REMARKS

FIG. 1

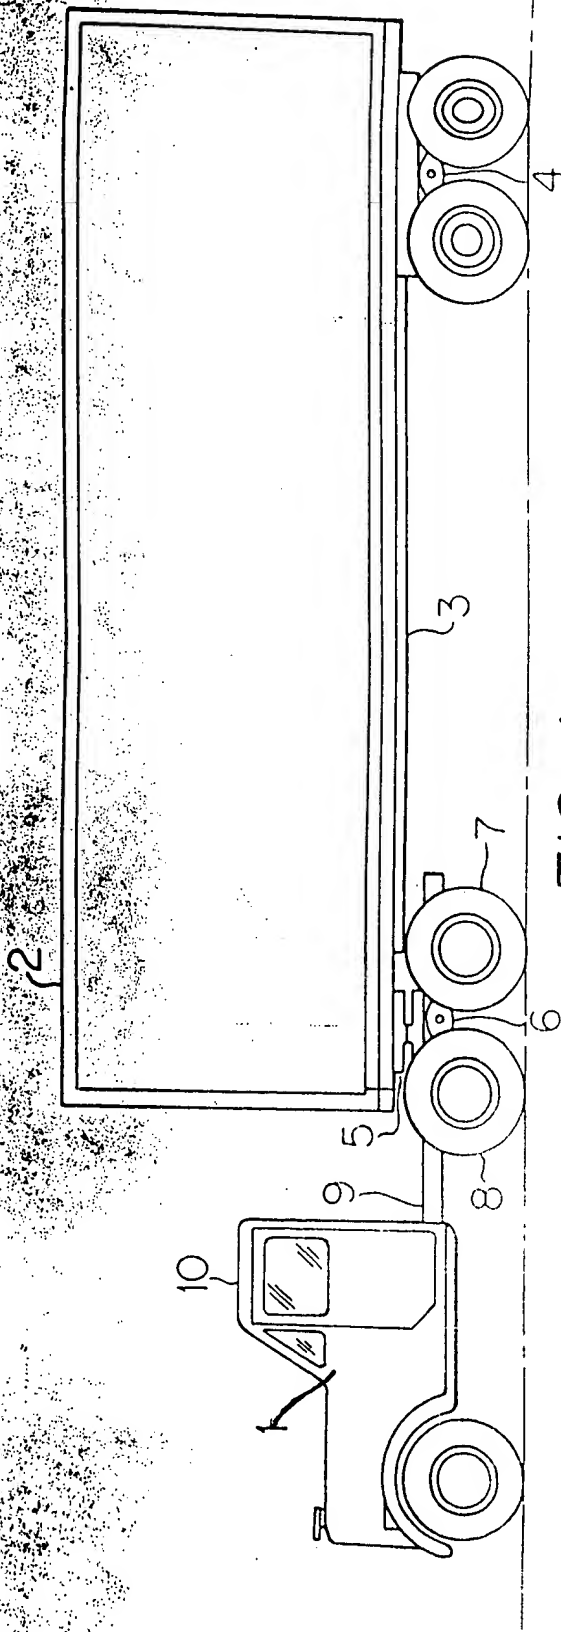
Proposed corrections for the drawing are shown in red on the copy of the drawing submitted herewith. The numeral "1" refers to the truck in general. The reference in the Office Action to numeral "31" is not clear; no reference to numeral "31" is found on page 8 of the specification; numeral "31" is shown in Figure 5. Numeral "31" in Figure 5 refers to one of several possible embodiments of the springs which can be used on the type of vehicle discussed in the specification. Where possible, the corrections have also been set forth above in the amendment.
